ATTACHMENT 3

PROPOSED ENVIRONMENTAL TECHNICAL SPECIFICATION CHANGE

NORTH ANNA UNITS 1 AND 2

DISCUSSION OF
PROPOSED TECHNICAL SPECIFICATION CHANGE
NORTH ANNA POWER STATION

Figure 5.2-1
 ORGANIZATION CHART
 ENVIRONMENTAL TECH SPEC IMPLEMENTATION

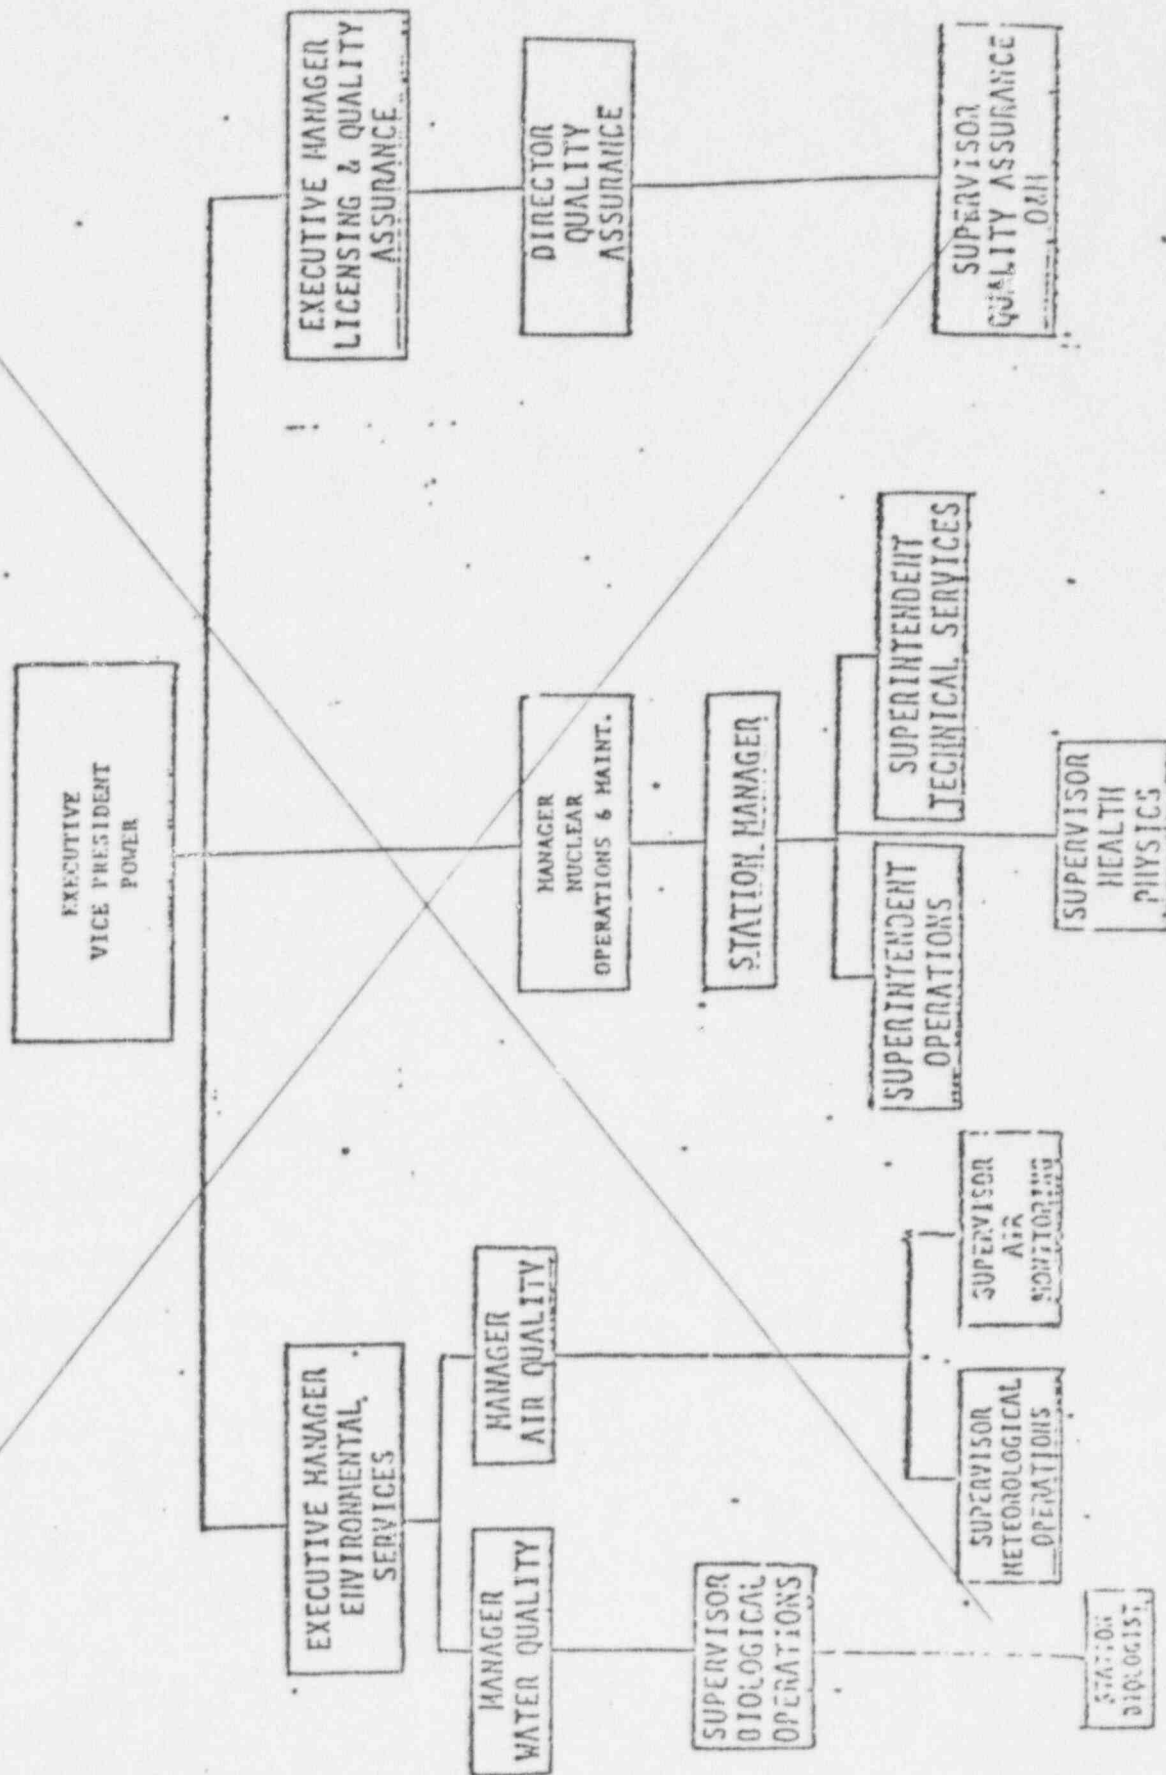
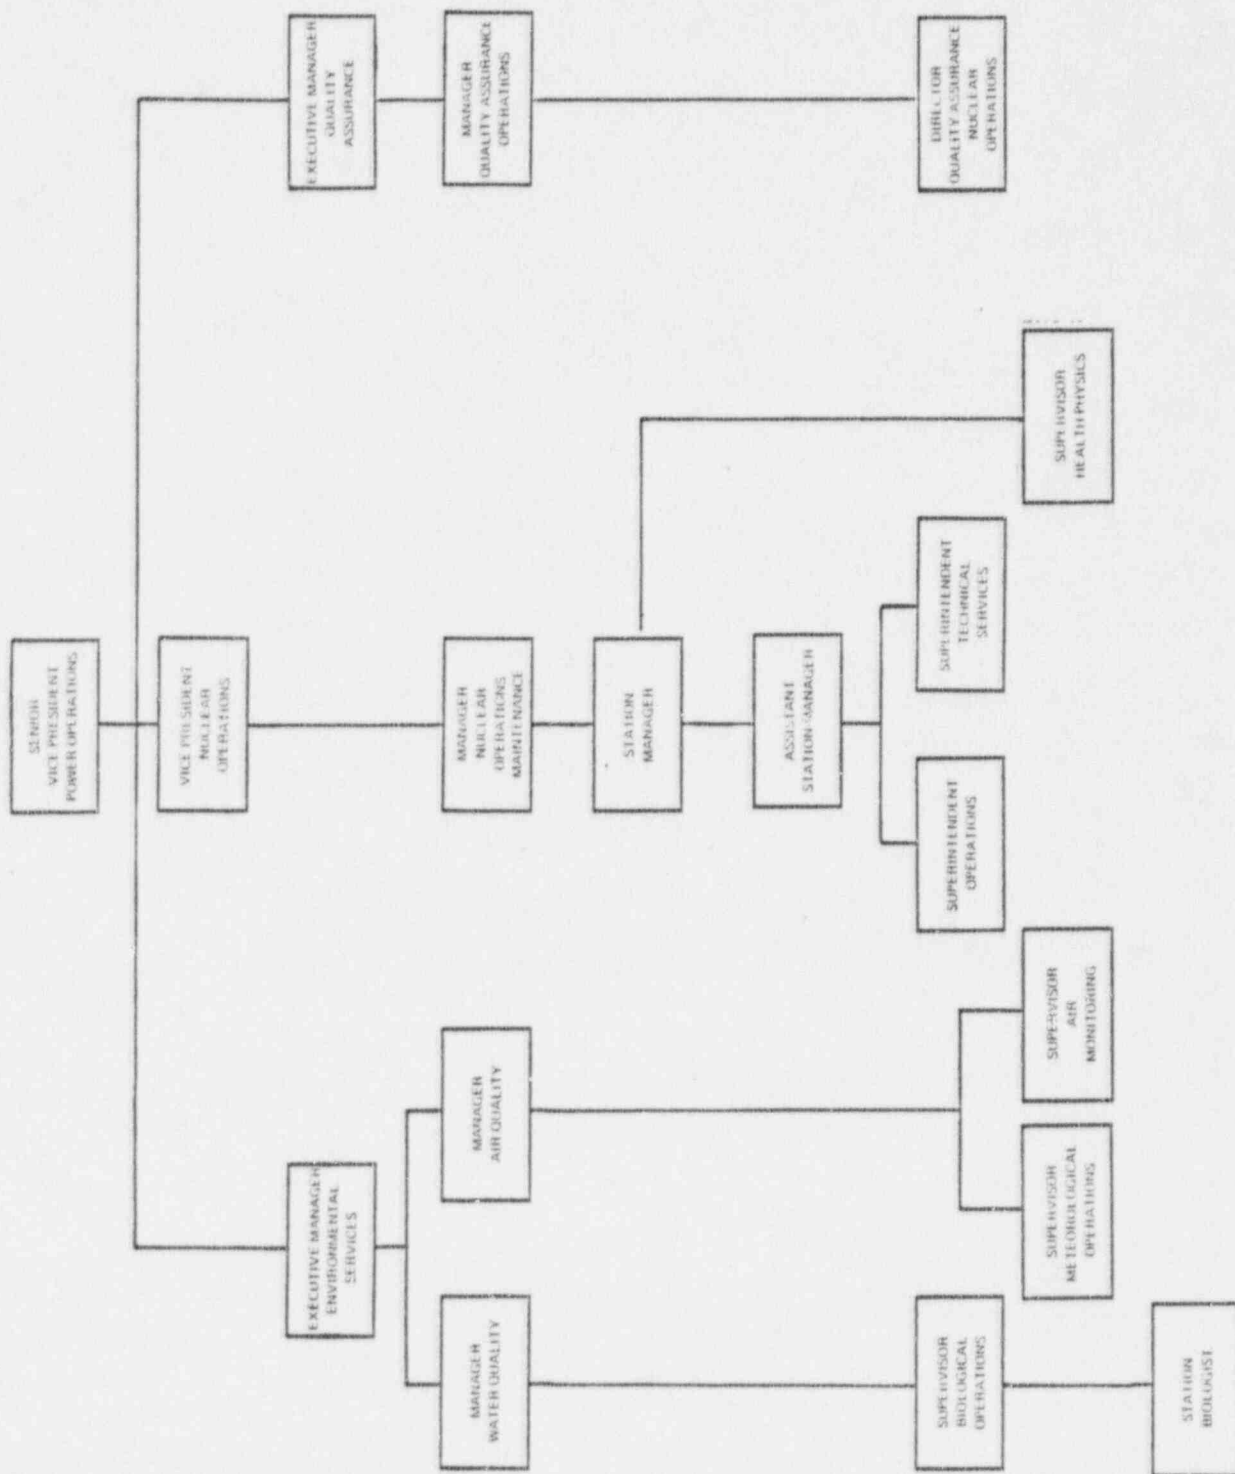
The organization charts for the North Anna Environmental Technical Specifications and the Appendix "A" Technical Specifications have been revised to reflect the restructuring of the Quality Assurance Department and changes to other organization titles. The previous title of Executive Manager-Licensing and Quality Assurance has been revised to Executive Manager-Quality Assurance. In addition, the positions of Manager-Quality Assurance, Operations and Director-Quality Assurance, Nuclear Operations are shown on the organization chart; however, those positions of the Quality Assurance Department which have no direct responsibility pertaining to the operation of the nuclear stations have not been shown on the Technical Specifications organization chart or referenced in the text of the Specifications.
